Subject: Response to Adequacy Review #2, Technical Revision #27:
Streamlined Groundwater Sampling Methodology and Reporting
Mine Land Reclamation Permit M-1977-300, Schwartzwalder Mine, Golden, Colorado

TECHNICAL REVISION 27. RESPONSE TO COMMENTS:

Subject: Technical Revision #27: Streamlined Groundwater Sampling Methodology and Reporting
Mine Land Reclamation Permit M-1977-300, Schwartzwalder Mine, Golden, Colorado

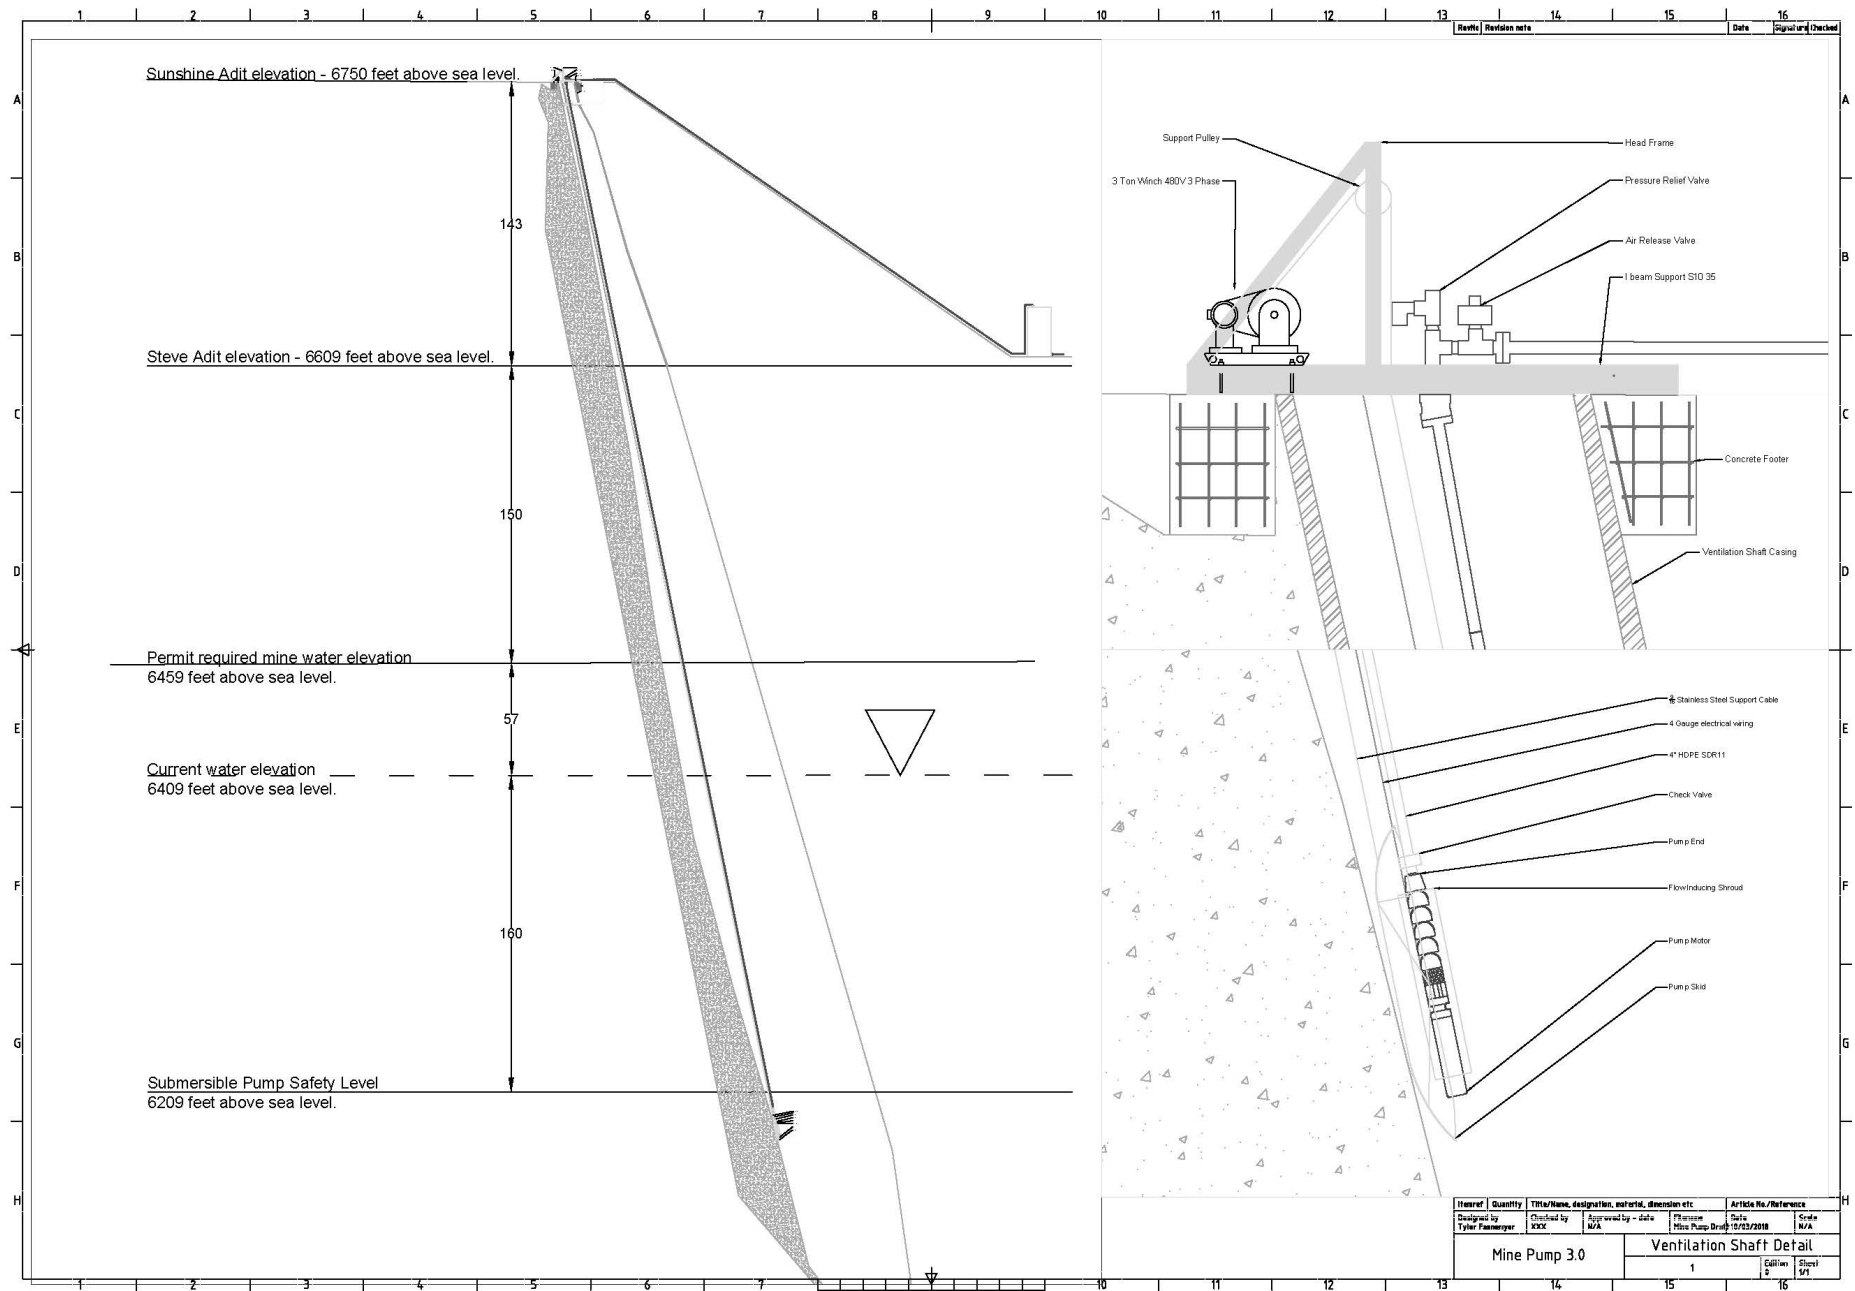
Comment 2: The new submersible pump location will require the installation of a 5" High Density Polyethylene Pipe. The pipe will convey untreated water from the mine pool to the water treatment plant. As required by Rule 6.4.21(7)(e), describe any release response procedures, redundancies, and "backup" measures necessary, appropriate, and economically reasonable to control, prevent and mitigate releases of the toxic materials from the containment facility (pipeline) outside the permit area during reclamation operations.

To address a line spill that could potentially occur outside of the permitted area, the operator proposes installing a secondary containment around the mine water effluent pipe. The primary 5-inch HDPE will be installed inside of a larger diameter 8-inch HDPE pipe and then routed to the collection tank secondary containment. In the event of a line rupture the untreated mine water will be controlled by the 8-inch containment line into the tank battery containment located on the mesa and to the immediate east of the RO water treatment plant. The quantity of water will be limited to a single water column due to the emergency shut down programming that is described in the previous paragraphs.

An alternate pumping location was identified and on August 31, 2018. A down-hole camera inspection was conducted in the Jeffrey Air Shaft to approximately 488-feet below the Sunshine Adit (approximately 348 feet below the Steve Adit). The successful camera inspection supports relocating the mine pool dewatering pump to the air shaft. The new submersible pump (50HP Goulds Model 7CSLC) will be lowered to approximately 550 feet below the Sunshine Adit (approximately 410 feet below the Steve Adit) on a custom fabricated housing shed via a winch system. The housing sled will protect and support the pump during installation. The dedicated winch system will be installed adjacent to the vent shaft on a concrete footer. The new winch system allows above-ground access to the pump for maintenance and repair, which supports the long-term health and safety goal of eliminating all underground work onsite. The construction and installation of the new dewatering pump will take place in fourth quarter 2018, a schematic of the design is shown on the following page for reference.
